Mount St. Helens Project Cowlitz River Levee Systems

2009 Level of Flood Protection Update Summary

Cowlitz River at Longview/Kelso, Washington

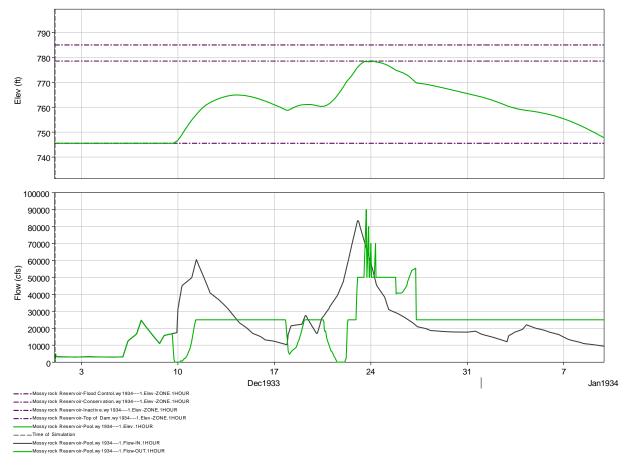
B.6.(section B.5) and B.9 (Section B.6.).
30	December 1933 event	12	Figure B7	Mentions that the oscillations are just a minor in the model that have no impact on downstre flow. Has this been verified? Can the glitch I addressed?	am instability does not affect the results at
31	All other pre- regulation water years	14	Figure B10	The symbol for m=0.85 is missing from the le unless "estimated" refers to m=0.85. If so, ple make this clearer.	
32	Historical Data	15		How was the historical period applied? Adjust plotting positions?	Added explanation of the application of the historical period.
33	Synthetic Hydrology Results	28	2	From the description, sounds like the combina of the synthetic curves with the total probabilitheorem was done right. But should describe name, or include the equation. Also, with interpolating probability, better to a probability scale rather than a log scale (meaning, interpowith the standard normal deviate for a given probability.)	ity it by

Figure C. 12. Variation in Stage based on changes in Bed Form Conditions

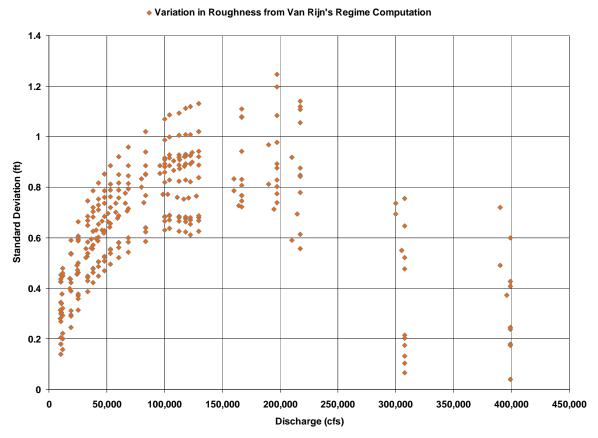
Faber	16	4.3.4.1	Says figure 4-3 suggests uncertainty can vary from 0.6 to 0.8 ft. The figure doesn't clearly suggest this, and perhaps this final estimate comes from more information. Should be stated more specifically.	The range given was change to a more appropriate value of 0.6 to 1.2. Text was added to indicate that this range is based on the range of discharge that is relavant to LOP, or near the 100-year frequency event.	Good. Comment closed.
Faber	24	5.1	Says "Results from FDA are reported in terms of probability of failure at a given index point for a given non-exceedance probability event." This is incorrect. Suggest "Results from FDA are reported in terms of a non-exceedance probability (or assurance) of containing a given %-chance exceedance event.	This change has been made.	Good. Comment closed.
Faber	27	5.2	Table 5-3 doesn't agree with table 5-2	Updated	Good. Comment closed.
Faber/Fields	26	5.2	How was the current level of protection determined from the FDA	Must look at the output from the FDA runs to determine the exceedance that corresponds	Concur. Comment closed.

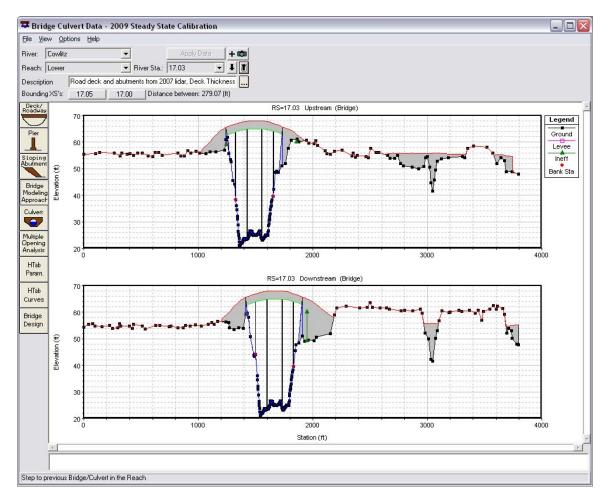
NWP Response: Utilizing a single geometry for the large range of events resulted in the anomaly noted; crossing profiles at BR1.35. As noted this is seen at a large event that is far beyond the 100% certainty of levee failure and does not affect the level of protection.

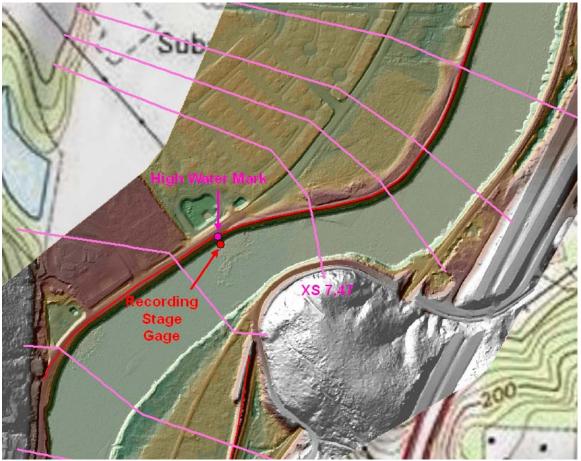
NWO Comment: There are a number of cross sections (\approx 20) where the upstream computed water surface is lower than the downstream. At these locations, the computed velocity is typically higher than surrounding sections. Typically profile dips are an indication that more or better geometry data is needed. The geometry data used in the analysis appears to be of good quality and obtaining additional surveys is likely cost and time prohibitive. Some explanation of the reason for profile dips should be included in the report.

Verify the channel velocity of >16 ft/s at RM7.47 for the calibration event.
